ATTACHMENT B

PROPOSED CHANGES TO APPENDIX A,  
TECHNICAL SPECIFICATIONS OF FACILITY OPERATING LICENSES  
DPR-19 AND DPR-25

DPR -19

DPR - 25

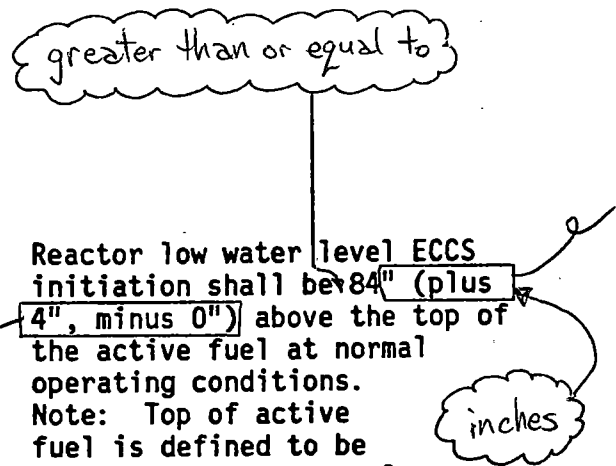
- D. Reactor low water level ECCS initiation shall be 84" (plus 4", minus 0") above the top of the active fuel at normal operating conditions.

Note: Top of active fuel is defined to be 360 inches above vessel zero (see Bases 3.2).
